As-Built Baseline Monitoring Report
FINAL VERSION
Lake Wendell Mitigation Project
Monitoring Year 0
Calendar Year of Data Collection: 2018

NCDEQ DMS Project Identification # 97081
NCDEQ DMS Contract # 6826
Neuse River Basin (Cataloging Unit 03020201)
USACE Action ID Number: SAW-2016-00876
NCDEQ DWR Project # 2016-0385
Johnston County, NC
Contracted Under RFP # 16-006477
Data Collection Period: March-June 2018, Submission Date: March 2019

RE: WLS Responses to NCDEQ DMS Review Comments for Task 6 Draft Baseline Monitoring Report and Task 7 Draft Monitoring Report Year 1 for the Lake Wendell Mitigation Project, NCDEQ DMS Full-Delivery Project ID #97081, Contract #6826, Neuse River Basin, Cataloging Unit 03020201, Johnston County, NC

Cross Section X-4

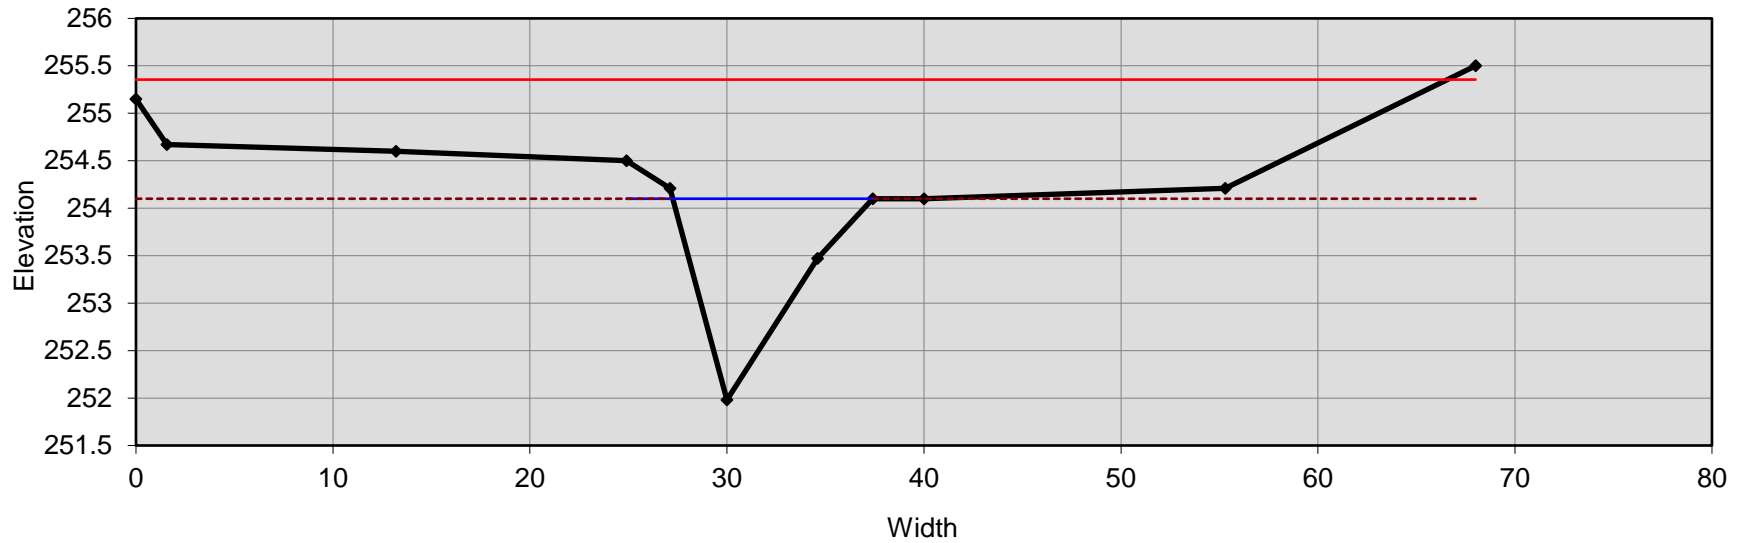
- 6. DMS Comment: Geomorph data: XS-4 (pool) looks like it has aggraded significantly from MY0 (I understand this is a small stream). Do you have any concerns about this? Shouldn't the BHR have updated based on this change with the new method?** WLS Response: WLS is not concerned about the adjustments to the referenced pool cross section, as it appears to be a minor channel adjustment towards the expected and desired stream dimension and stability. WLS used the new method for calculating adjusted BHRs. We have corrected/ adjusted the bankfull elevation change using the low TOB and as-built cross-sectional area. The result is less than one tenth elevation change and therefore the BHR is ~1.0.
